BOARD OF WATER SUPPLY

Subject: Testimony on Draft Amended Interim Instream Flow Standards in the Surface Water Hydrologic Unit of He`eia (3028): He`eia Stream, O`ahu

Subject: Testimony on Draft Instream Flow Standard Assessment Report for the Hydrologic Unit of He'eia (3028)

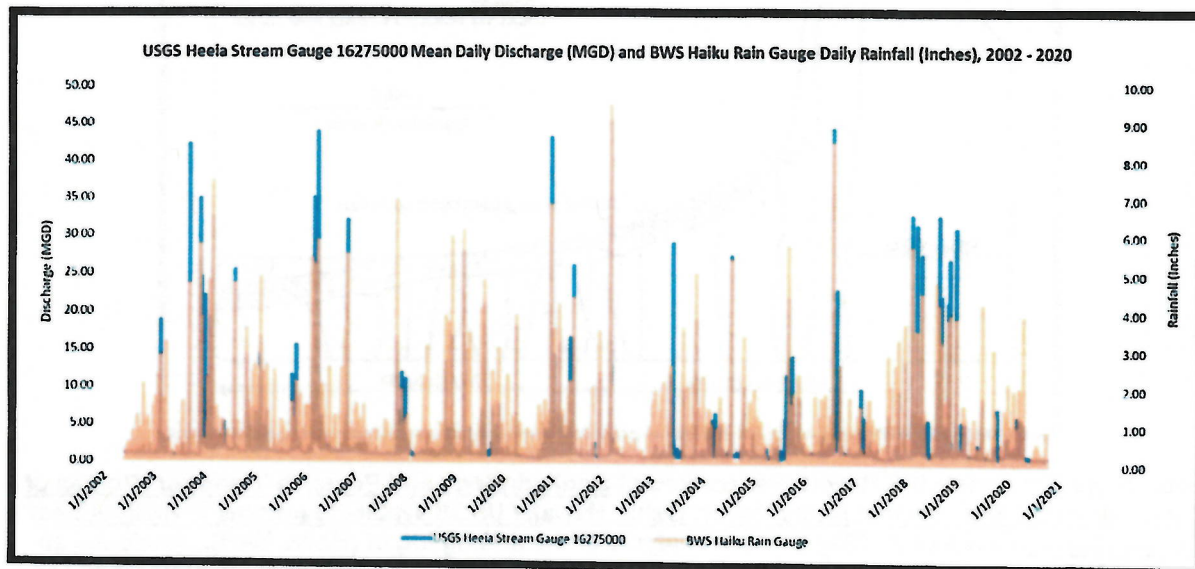
However, subsequent BWS research with the National Weather Service and the University of Hawaii confirmed that there were no rain gauges in He'eia with that duration of historic rainfall data. Instead, as shown on Figure 3-10 in the Draft Heeiea IFS Report, CWRM referenced interpolated islandwide rainfall trends related to the University of Hawaii's Rainfall Atlas of Hawaii program. These interpolated trends indicate a zero to 1 percent rainfall decrease in the He'eia area per decade.

This in fact may present a significant effect on He'eia streamflow. If rainfall decline is closer to 1 percent per decade, over the period of 1920 - 2012 this translates to a decrease of approximately 9 percent.

Furthermore, the timing of the apparent He'eia streamflow decline should be compared to the timing of historic increases and decreases in rainfall, rather than relying solely on interpolated islandwide trends. Since 1920, there have been major swings in rainfall, with decades of relatively wet and relatively dry weather. Streamflow should be compared to these rainfall time series for those historic timeframes that have data for both parameters, to improve the understanding of factors affecting streamflow.

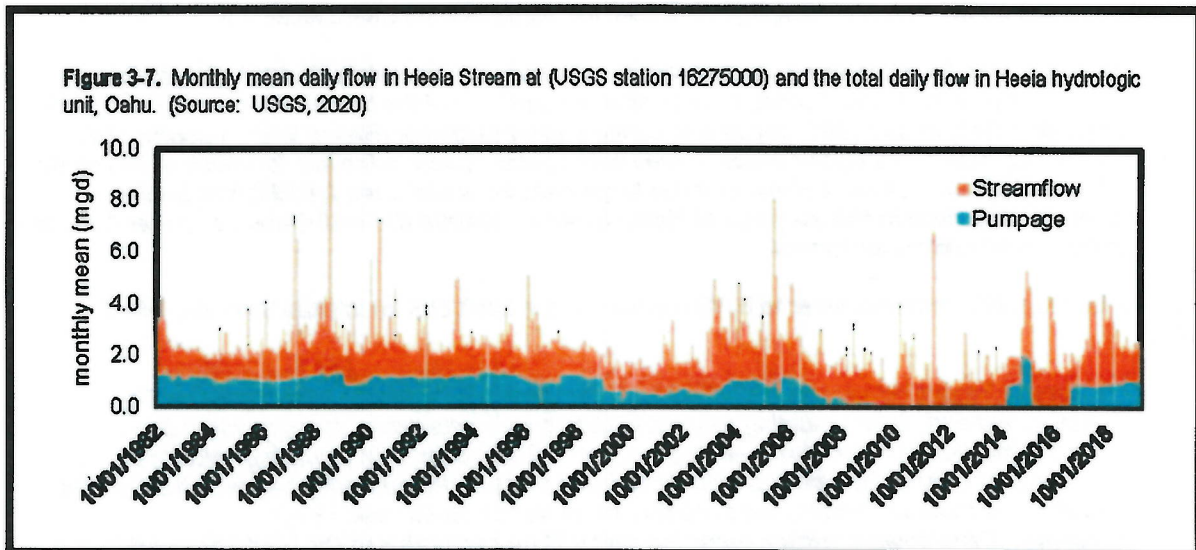
Finally, Figure 3-7 of the Draft Heeia IFS Report reflects the incomplete understanding of relationships between Haiku Tunnel, Haiku Well, Iolekaa Well and He`eia streamflow. **If, as previously suggested by CWRM staff, Haiku Tunnel is the sole factor influencing Heeia streamflow relative to Haiku Well, Iolekaa Well, or historic rainfall, then the lack of increase in streamflow between c.2010 - 2014 does not make sense. Haiku Tunnel was out of service during this period.**

If rainfall were taken into account, the period c.2010 - 2014 at the BWS Haiku Rain Gauge was not characterized by unusually low rainfall. Consideration should therefore be given to Haiku Well (and by association, Iolekaa Well), both of which were in service during the period c.2010 – 2014.

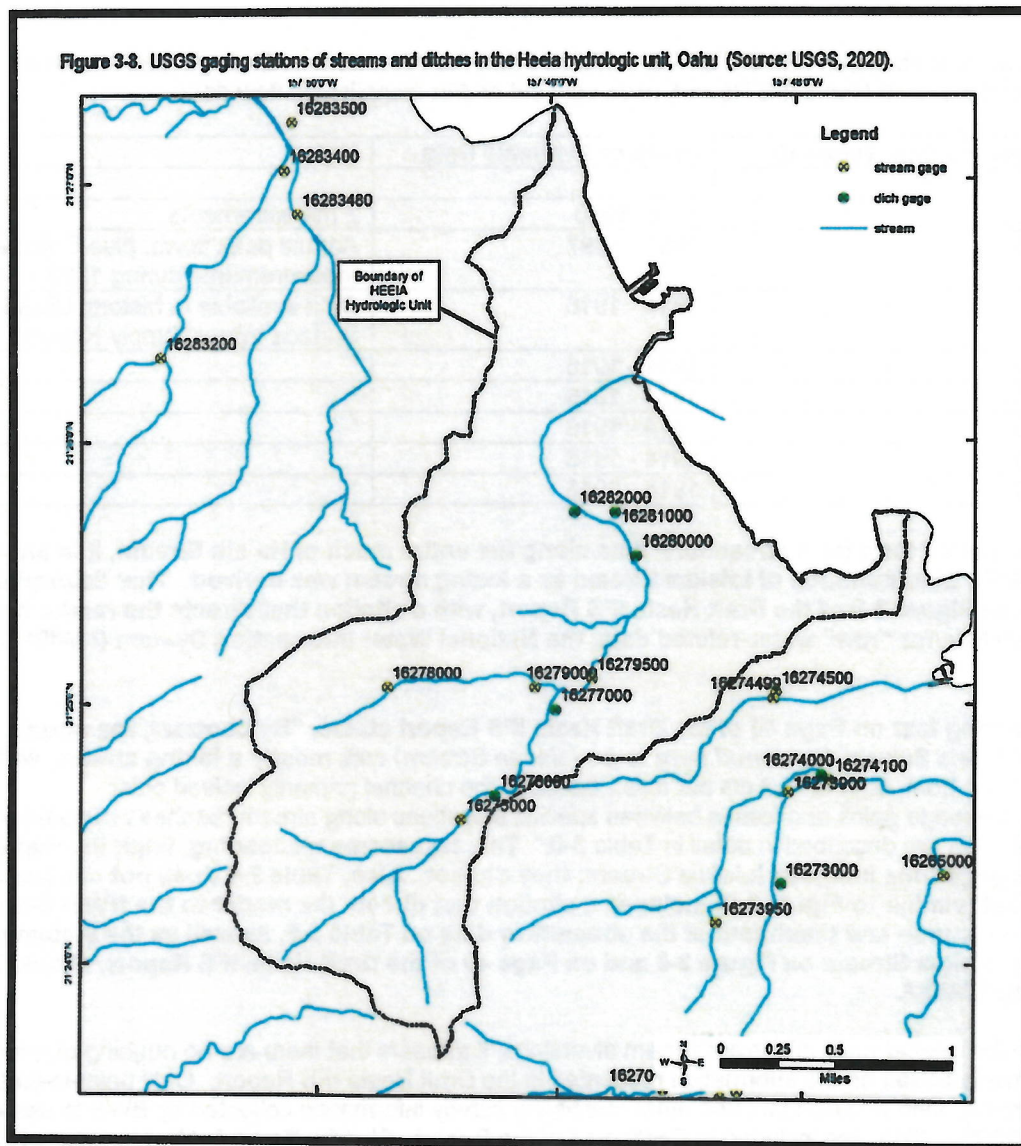
Page 31 of the Draft Heeia IFS Report notes limited long-term streamflow data along the entire reach of He`eia Stream. The only permanent stream gauge is USGS Stream Gauge 16275000. As noted above, this gauge is located a short distance downstream of Haiku Tunnel and Haiku Well, along the upper reach of He`eia Stream and above the confluence with Iolekaa Stream. One other stream gauge had more than a few years of historic data; USGS Stream Gauge 16278000, collected data between c.1940 – 1970 along the upper reach of Iolekaa Stream.

Subsequent BWS research with the USGS confirmed that the other stream/ditch gauges shown on Figure 3-8 of the Draft Heeia IFS Report, have very old and/or inapplicable flow data:

Figure 3-9. Seepage run results from near simultaneous point measurements in Heeia hydrologic unit, Oahu. (Source: USGS, 2020).

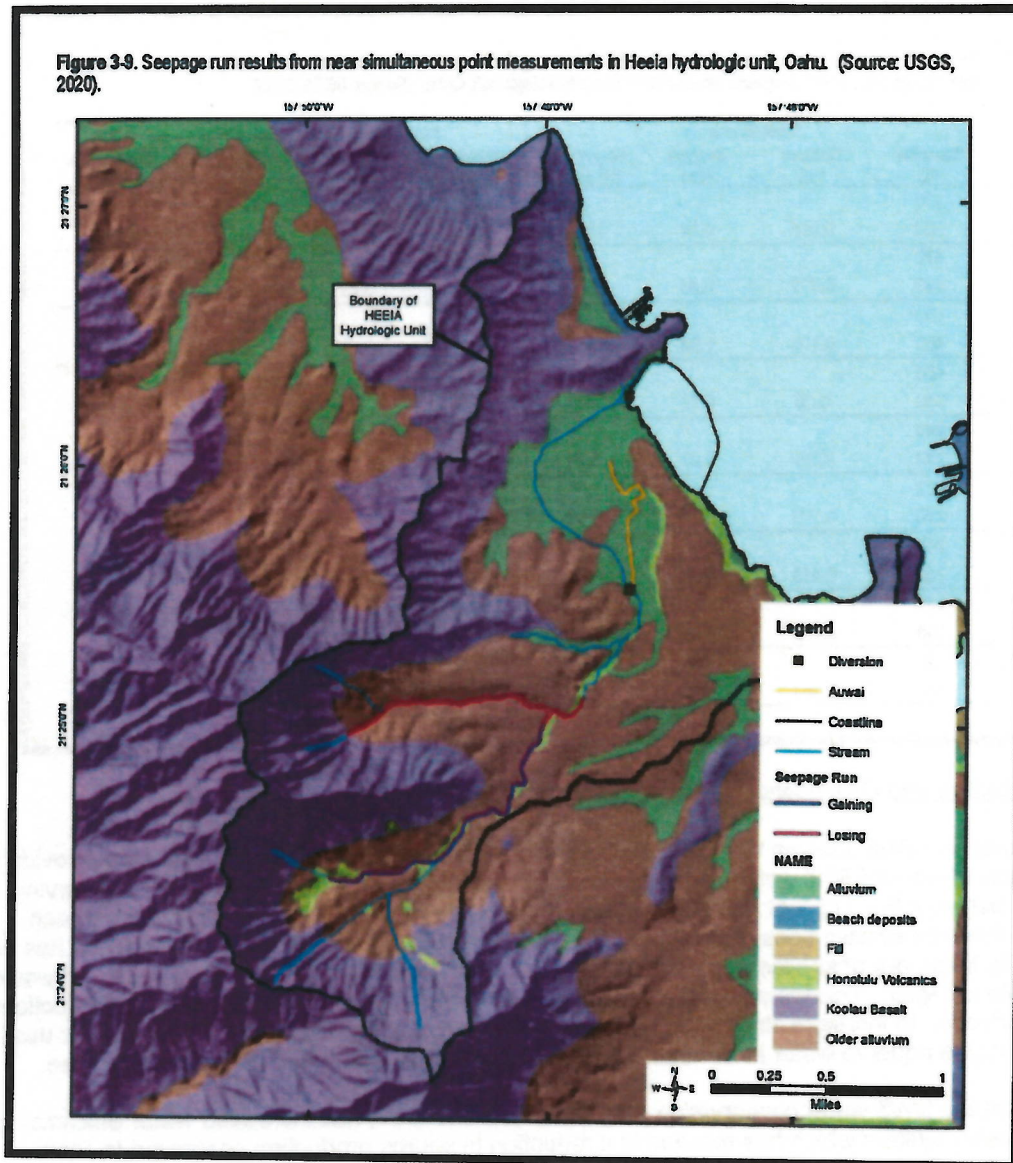
Given the limited long-term streamflow data along the entire reach of He`eia Stream, it is unclear how CWRM's determination of Iolekaa Stream as a losing stream was derived. This determination is shown on Figure 3-9 of the Draft Heeia IFS Report, with a citation that directs the reader to the USGS Web Site for "raw" water-related data, the National Water Information System (NWIS) Data Portal.

Accompanying text on Page 40 of the Draft Heeia IFS Report states, "By contrast, the north branch of Heeia Stream (*assumed here to be Iolekaa Stream*) was mostly a losing stream, with losses ranging from -0.34 to -3.2 cfs per mile...because the channel primarily incised older alluvium...Seepage gains and losses between specific elevations along stream reaches estimated from Izuka et al 1993 are described in detail in Table 3-6." This text seems misleading, implying that the USGS seepage runs included Iolekaa Stream; they did not. Also, Table 3-6 does not cite Izuka et al, 1993, but (similar to Figure 3-9) includes a citation that directs the reader to the NWIS Data Portal. The source and timeframe of the streamflow data on Table 3-6, as well as the statements regarding Iolekaa Stream on Figure 3-9 and on Page 40 of the Draft Heeia IFS Report, should be clarified by CWRM.
